AMENDMENTS TO THE DRAWINGS

Annotated Marked-Up Drawing

Figure 5

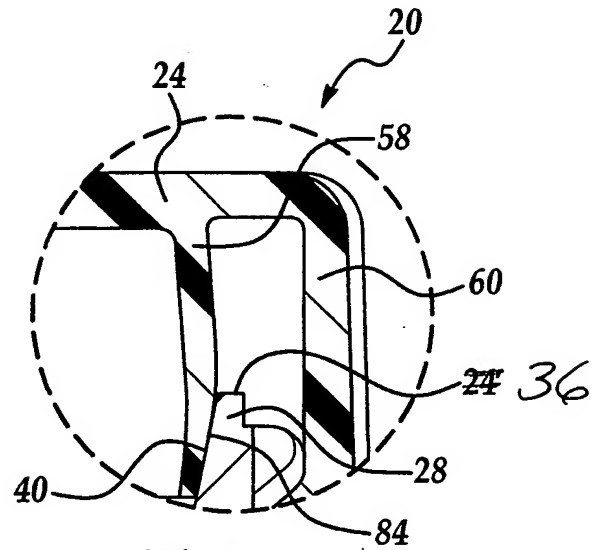
Please substitute the enclosed Replacement Sheet containing FIGS. 4-6C for the corresponding sheet of the drawings as filed. An Annotated Marked-up Drawing shows the reference numeral correction in FIG. 5 of this drawing sheet.

Claim 13 recites a container having a finish with an open mouth surrounded by an end 36 and an internal tapered surface 40 that extends to this end. The end 36 of the finish 28 is clearly illustrated in amended FIG. 5, as is the internal tapered surface 40 that extends to the end 36. (The reference numeral correction in FIG. 5 clearly is supported at page 4, lines 20-22 of the application text as filed.)
